Office Action Summary

10/761,185

MUTCHLER, AUSTIN W.

DETAILED ACTION

FIG. 1

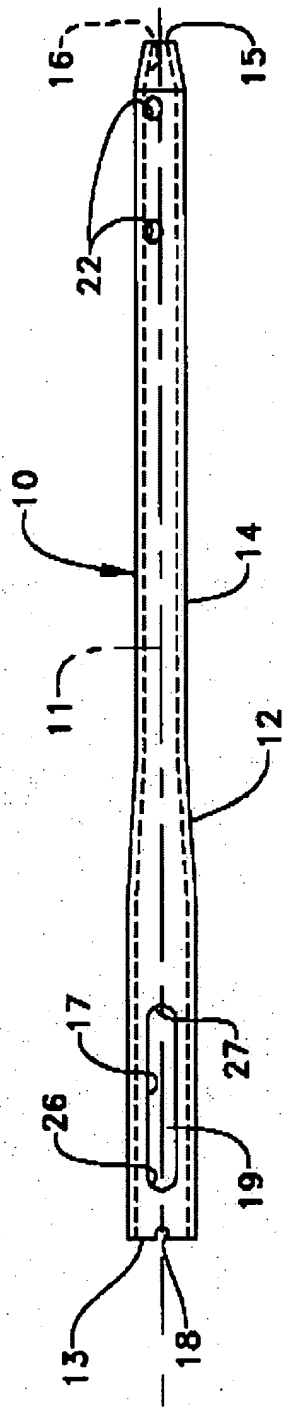
Border discloses an intramedullary nail for use with a first fastener and a second fastener for use in orthopedic surgery, said nail comprising a body (Fig. 1, 10) defining a longitudinal axis thereof, the body defining an aperture (Fig 1, 16) therethrough, the aperture having a first portion (Fig 1, 17) capable of cooperation with a first fastener to provide dynamic fixation and having a second portion (Fig 1, 22) capable of cooperation with a second fastener to provide static fixation. The definition of axis, according to the Merriam-Webster Online Dictionary, is "a straight line about which a body or a geometric figure rotates or may be supposed to rotate." Since the nail can rotate in any direction around any line or point where the nail exists in space, the axes can be anywhere in the body of the nail, in any orientation. This definition of axis will be applied throughout this office action. The "portions" can be considered part of the slot since they are continuous with the slot.

The slot (Fig 1, 16) has a rectangular central section. As seen in Fig 1, the cross section of the middle of the slot has a rectangular section. It also has a cylindrical end section (Fig. 1, 26) adjoining the rectangular central section. The cylindrical end section is capable of matingly fitting with the first fastener. The cylindrical end section is capable of slidable fit and threadable fit with the first fastener. The definition of thread, according to the Merriam-Webster Online Dictionary, is "to pass something through in the manner of a thread". The end is capable of threadable fit with the first fastener, since the screw could be placed through the end section. The aperture is capable of

providing for a slidable fit of the first fastener with the body along the longitudinal axis of the body. If the diameter of the fastener's body is smaller than the diameter of the aperture of the aperture, there would be room enough for the screw to slide in the aperture. The slot further includes a second cylindrical end section (Fig. 1, 22) opposed to the first mentioned cylindrical end section. The nail includes a resorbable component (Fig. 1,19) for cooperation with said body adjacent the aperture. The resorbable component comprises external threads formed thereon (column 4, lines 31-35). The slot defines a slot axis thereof, the slot axis being perpendicular to the longitudinal axis of said body.

Border further discloses a kit for use in orthopedic surgery, the kit comprising: a first fastener (Fig. 3, 34); a second fastener (Fig. 3, 34); and an intramedullary nail comprising a body (Fig. 1, 10) defining a longitudinal axis thereof, body defining an aperture therethrough (Fig 1, 16), the aperture having first portion (Fig 1, 17) capable of cooperation with said first fastener to provide dynamic fixation and having second portion capable of cooperation with said second fastener to provide static fixation (Fig 1, 22). The slot has a rectangular central section. As seen in Fig 1, the cross section of the middle of the slot has a rectangular section. It also has a cylindrical end section (Fig. 1, 26), which is attached to the rectangular section. The cylindrical end section is capable of matingly fitting with the first fastener. The cylindrical end section is capable of slidable fit and threadable fit with the first fastener. The aperture is capable of providing for a slidable fit of the first fastener with said body along the longitudinal axis of said body. The slot further includes a second cylindrical end section (Fig. 1, 22)

opposed to the first mentioned cylindrical end section. The kit comprises a resorbable component (Fig. 1,19) capable of cooperation with said body adjacent the aperture.

Border further discloses an intramedullary nail for use in orthopaedic surgery, said nail comprising: a body (Fig. 1, 10) defining a longitudinal axis and a transverse axis thereof, the transverse axis being normal the longitudinal axis, the body defining an aperture (Fig 1, 16) therethrough, the aperture being substantially longer in the longitudinal axis than in transverse axis. The aperture is longer in some directions than others, and, applying the definition of axis, the axis can exist anywhere the nail is and in

any direction. The aperture defines an enlarged portion (Fig 1, 17) thereof along the longitudinal axis. Enlarge is defined by the Merriam-Webster Online Dictionary as "extend." It is longer in one direction than the other (Fig. 1, 17), hence it is extended in one direction and enlarged. The aperture has a rectangular central section. As seen in Fig 1, the cross section of the middle of the slot has a rectangular section. The enlarged portion forms a generally cylindrical section and is positioned adjacent an end of the aperture. Viewing the enlarged portions from above the nail, as in Fig. 1 and Fig. 5, they have a generally cylindrical shape. Border discloses a fastener (Fig 3, 34) capable of cooperation with the body. The cylindrical section of said body is capable of matingly fitting with said fastener. The cylindrical section is capable of slidable and threadable fit with said fastener. The aperture is capable of a slidable fit with the fastener with said body, along the longitudinal axis of said body. The aperture further includes a second enlarged cylindrical section (Fig. 1, 22) opposed to the first mentioned cylindrical section. Border discloses a resorbable component capable of cooperation with said body adjacent the aperture (Fig. 1,19). The resorbable component comprises external threads formed thereon (column 4, lines 31-35). The enlarged portion is adjacent an end of the aperture. According to the Merriam-Webster Online Dictionary, the definition of adjacent is "not distant". The enlarged portion is only a few inches from the end of the aperture, which is not distant.

Fig. 9

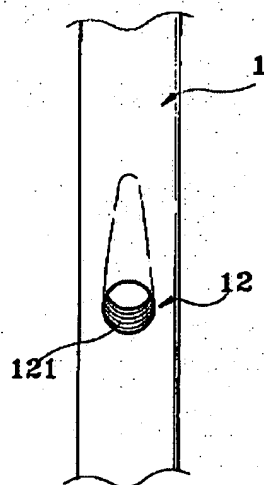
Emilio et al. disclose the body adjacent the first mentioned cylindrical end (Fig. 12 below, 130) defining internal threads therein (Fig. 12, 131) and the body adjacent the second cylindrical end (Fig. 12, 140) defining internal threads therein (Fig. 12, 141) (see also Fig. 9 below), for engagement and guiding of screws (Column 5, lines 19-24).

Fig. 12

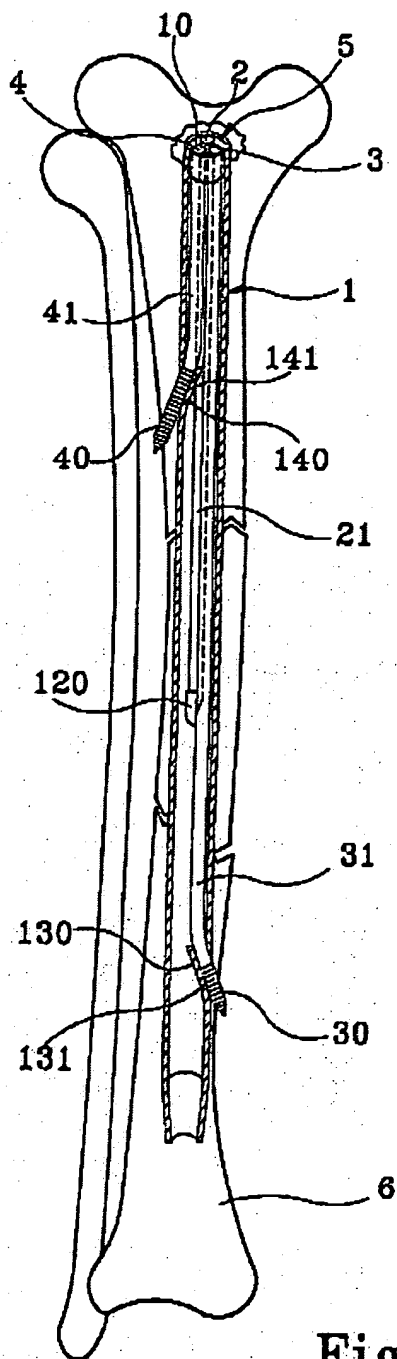
It would have been obvious to a person having ordinary skill in the art at the time the invention was made to construct the body adjacent the aperture of Border with the internal threads of Emilio et al., in order for the internal threads to engage and guide screws used to fasten the nail to the bone (Column 5, lines 19-24).
